**CHABOT-LAS POSITAS  
COMMUNITY COLLEGE DISTRICT  
PURCHASING DEPARTMENT**

**Addendum No. 4  
INVITATION TO BID No.: B20/21-08  
Agriculture Science, Horticulture Facility Project**

CLPCCD - LAS POSITAS COLLEGE  
**AGRICULTURE SCIENCE HORTICULTURE FACILITY**  
3000 CAMPUS HILL DRIVE,  
LIVERMORE, CA 94551

**AD121**

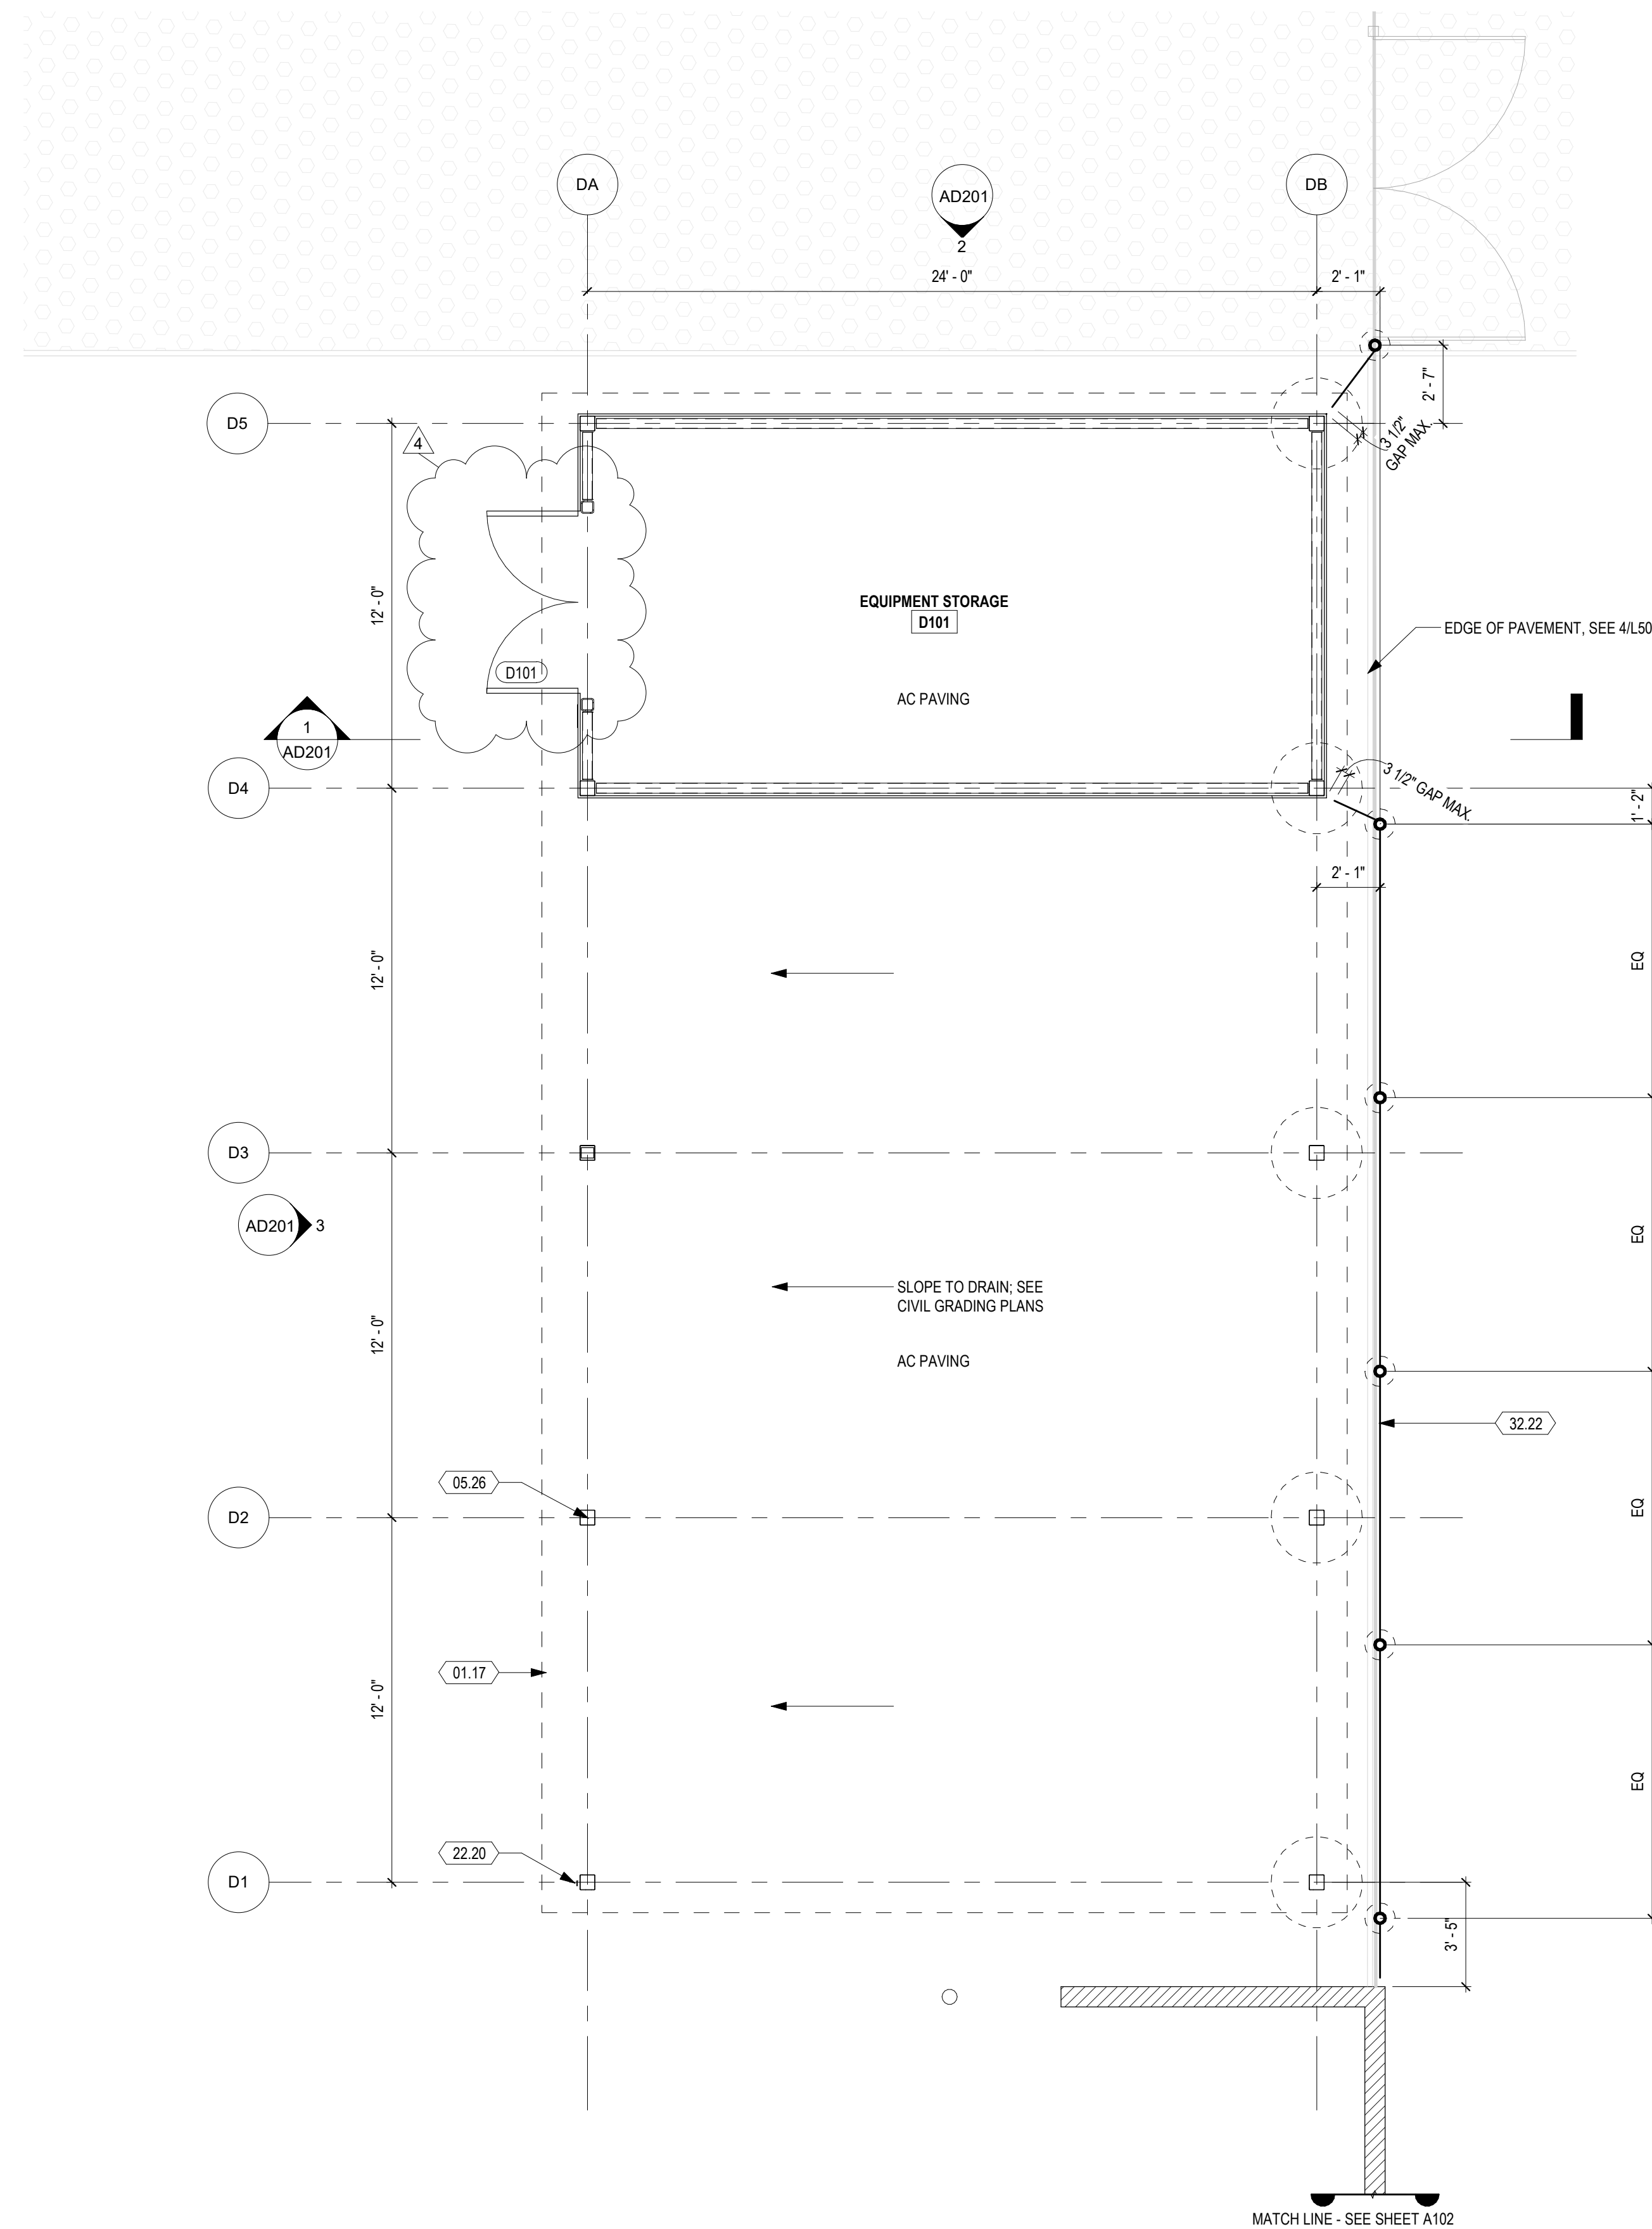
9. **Sheet AD121 – Equipment Storage Floor Plan:** Add Door Tag D101 to Equipment Storage D101.
  10. **Sheet A801 – Door and Window Schedules and Types:**

**A801**

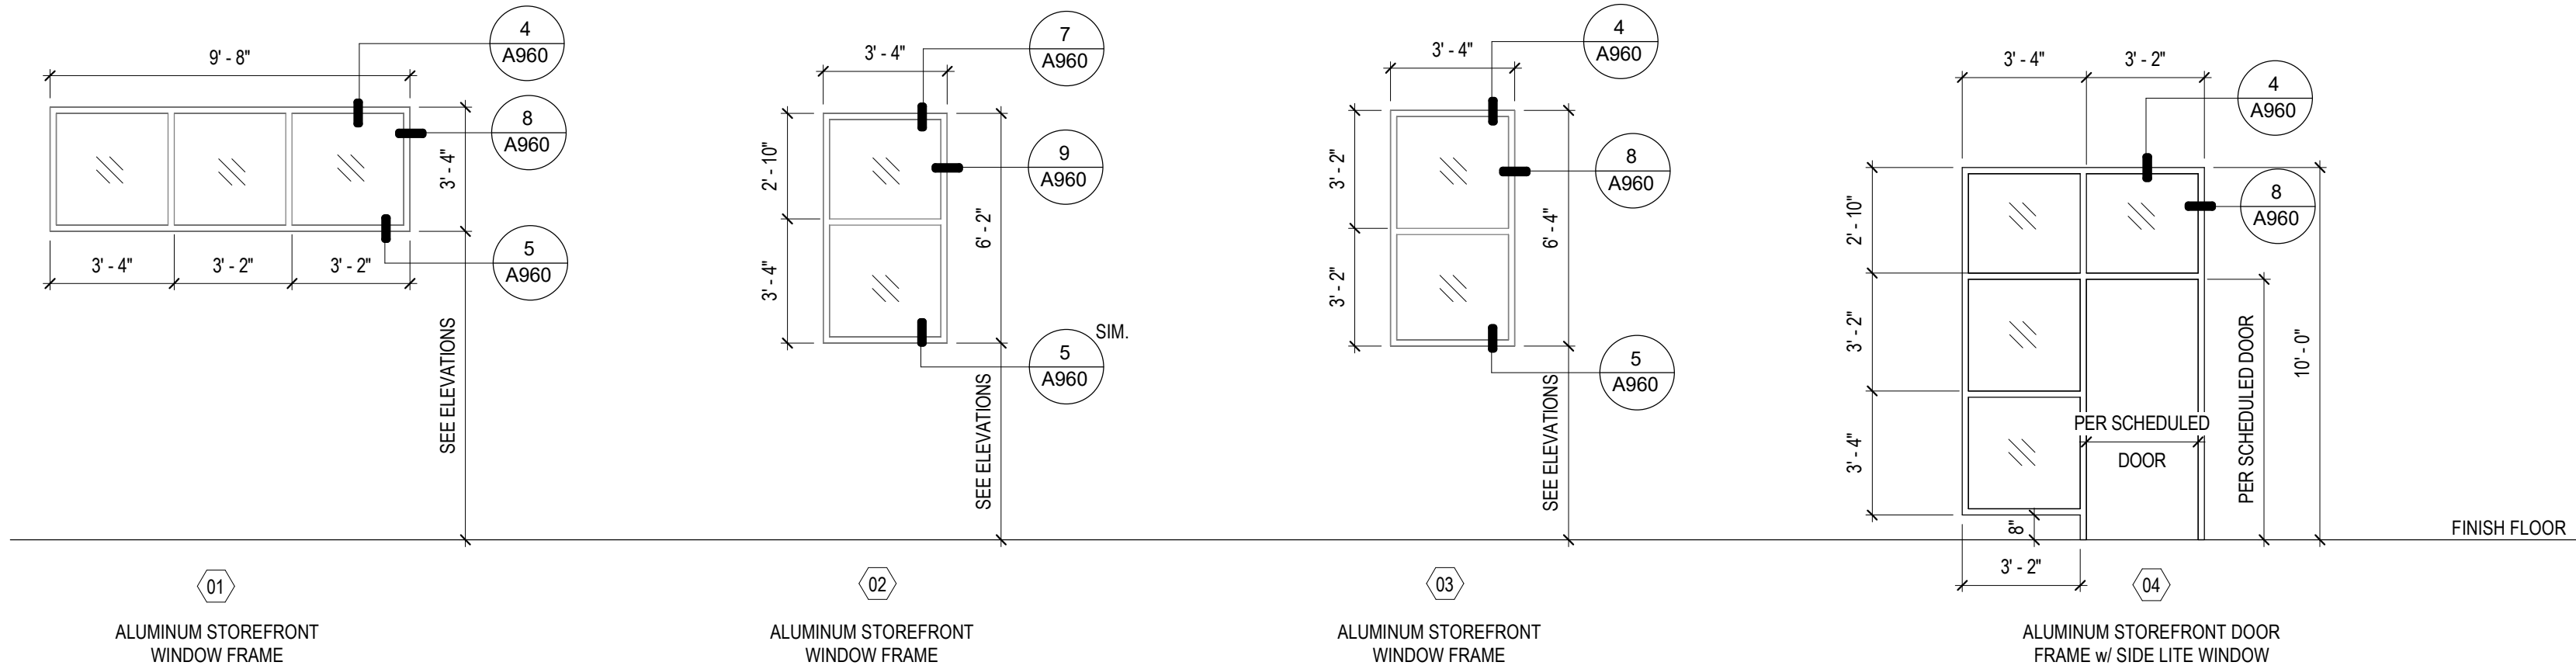
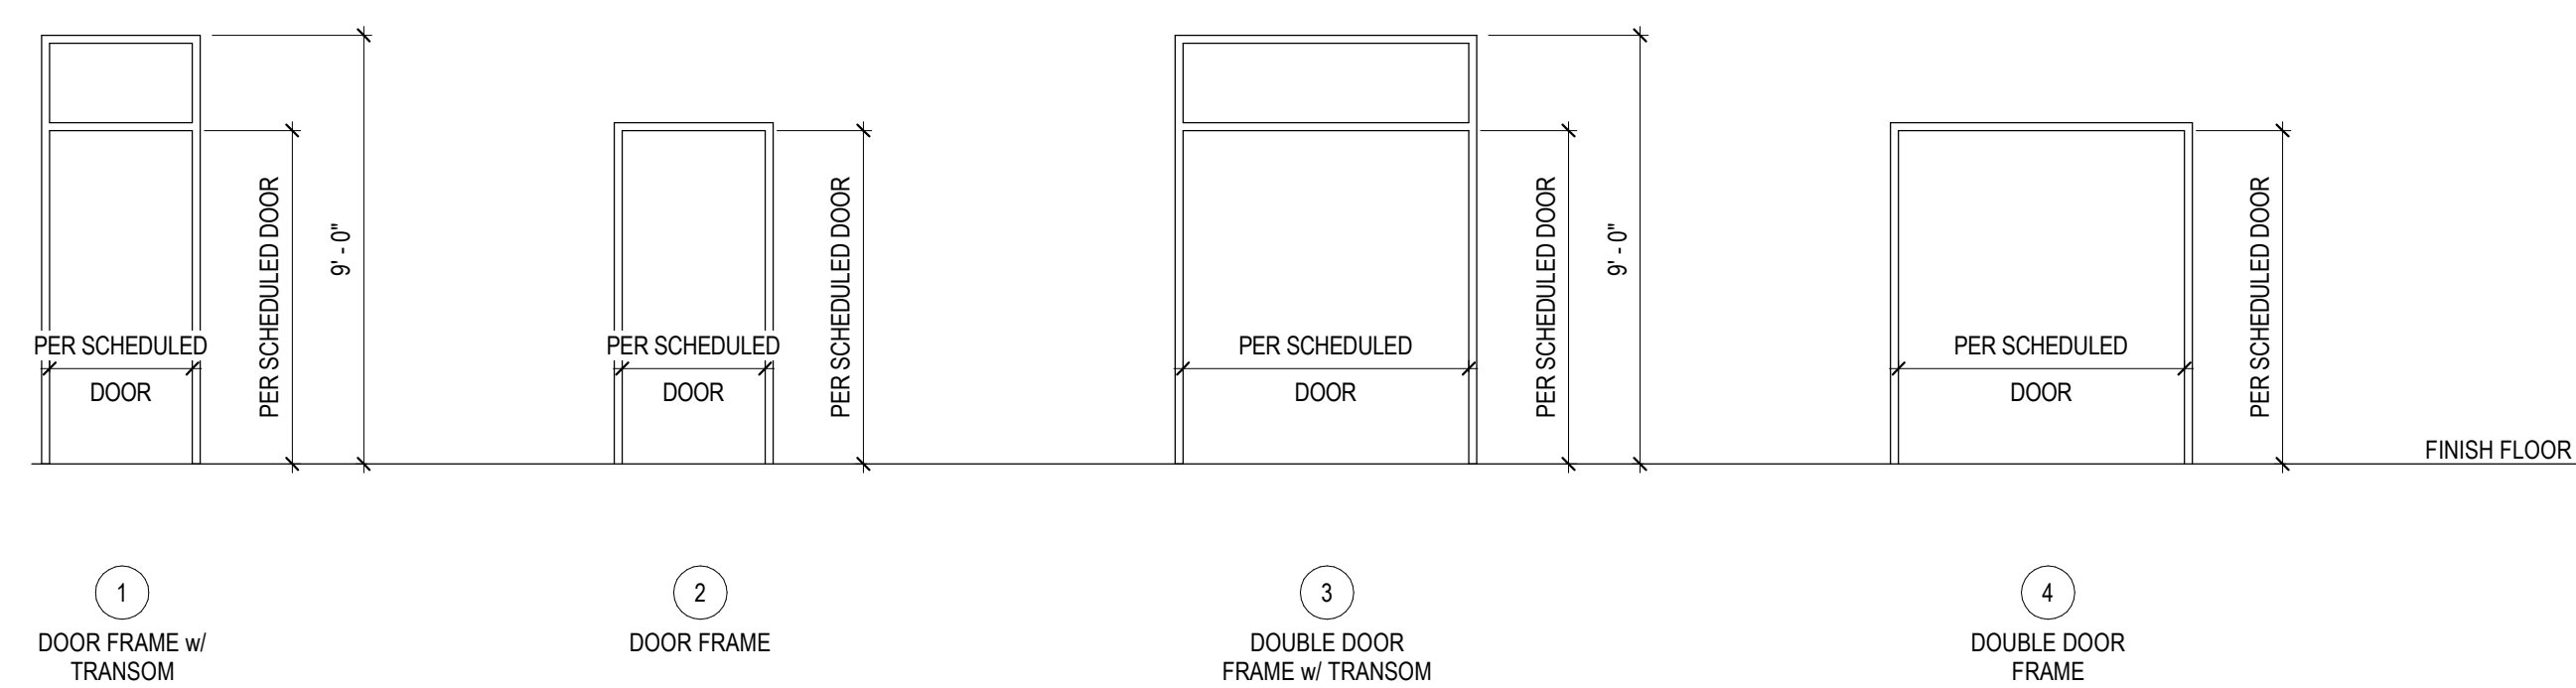
- a. Updated Door Schedule.
    - b. Added EE door type elevation.
  11. **Sheet EA141 – Classroom Building Floor Plan Lighting:**
    - a. Added exit light.

**TA100**

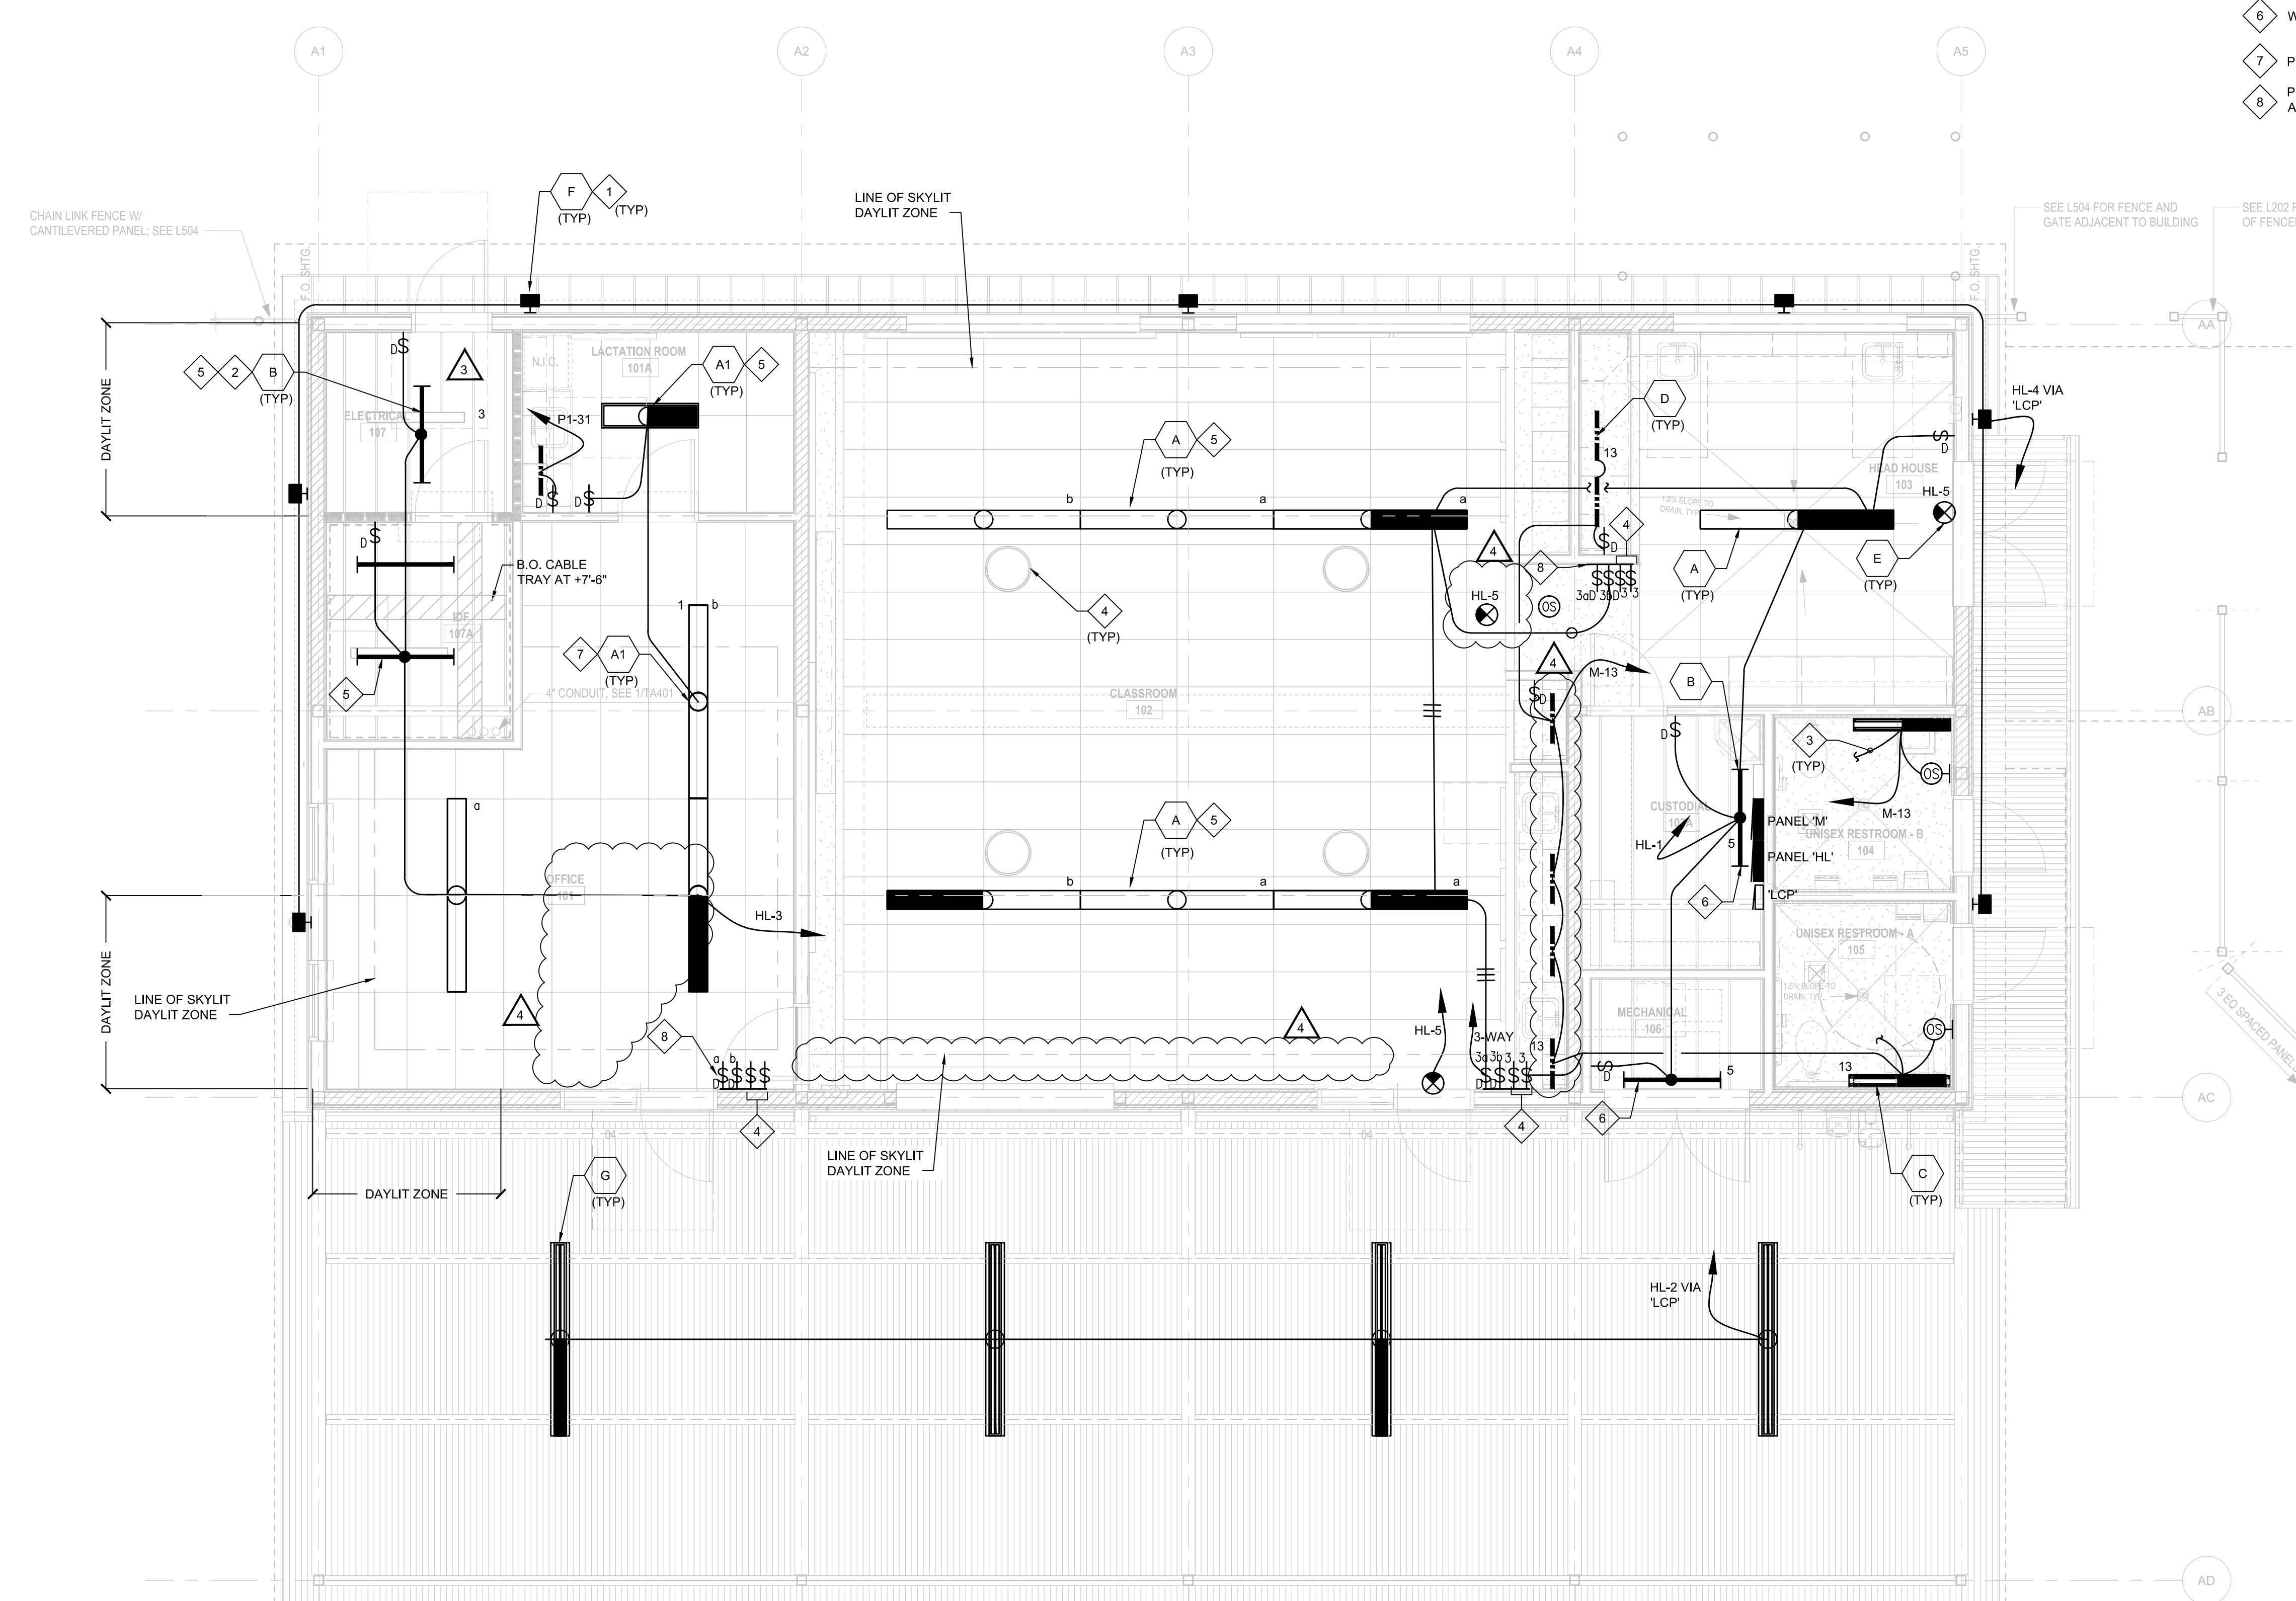
- b. Updated alignment of undercounter lighting.
    - c. Deleted stray circuit lines.
  12. **Sheet TA100 – Telecom System Diagram:** Revised Keynote TN3 from Single Mode Fiber to Multimode Fiber.
